Access Compliance Report

Public Rights-of-Way

(Curb Ramps)

Intersection ID: 3795	Main Street: FOUNTAINGROVE_DR	Cross Street: TOWTON_CT	Location: E
ADA ID: ADDCE20DE5F6	Ramp Type: Perp	Initial Pass/Fail: Fail	Overall Compliance: No
Severity Score: 8.75			
Codes/Mitigation Info/Possible Solution		Field Measurements/Component Compliance

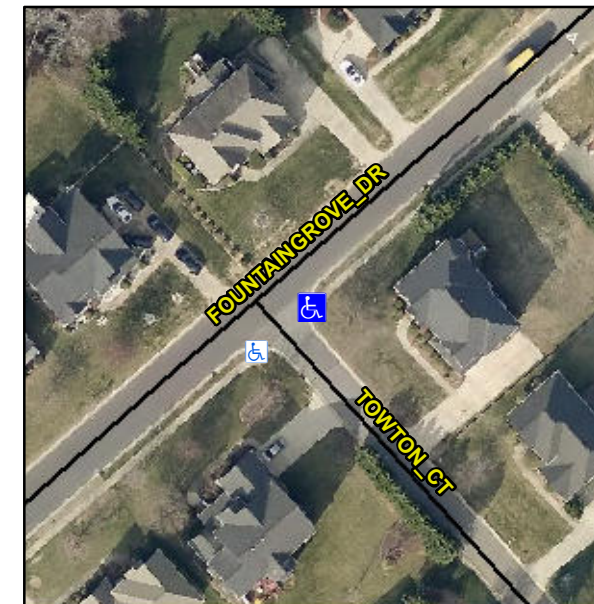
Possible Solutions:

Remove & Replace Entire Ramp.

PROW/ADA:

Not Found, R304.5.1

Compliance	Description	Data	Compliance	Description	Data
N/A	Ramp Length (in)	49.0	Yes	Ramp Slope (%)	6.0
No	Ramp Width (in)	43.0	Yes	Ramp XSlope (%)	1.5
N/A	Flare Type LT	N/A	N/A	Flare Type RT	N/A
N/A	Flare Slope LT (%)	N/A	N/A	Flare Slope RT (%)	N/A
N/A	Flare Traversable LT?	N/A	N/A	Flare Traversable RT?	N/A
N/A	Landing Length (in)	N/A	N/A	DWS Provided?	N/A
N/A	Landing Width (in)	N/A	N/A	DWS Contrast?	N/A
N/A	Landing Slope (%)	N/A	N/A	DWS Length (in)	N/A
N/A	Landing X Slope (%)	N/A	N/A	DWS Full Width?	N/A
N/A	Landing Curb? (Y/N)	N/A	N/A	DWS Offset (in)	N/A
N/A	Shared Landing?	N/A			
N/A	Gutter Ponding?	N/A	N/A	Gutter Slope (%)	N/A
N/A	Gutter Lip Ht (in)	N/A	N/A	Gutter X Slope (%)	N/A
N/A	Painted X Walk1?	No	N/A	Painted X Walk2?	N/A
	X Walk 1 Direction	To SW		X Walk 2 Direction	N/A
N/A	X Walk 1 Width (in)	N/A	N/A	X Walk 2 Width (in)	N/A
	X Walk 1 Slope (%)	1.9		X Walk 2 Slope (%)	N/A
	X Walk 1 X Slope (%)	4.3		X Walk 2 X Slope (%)	N/A
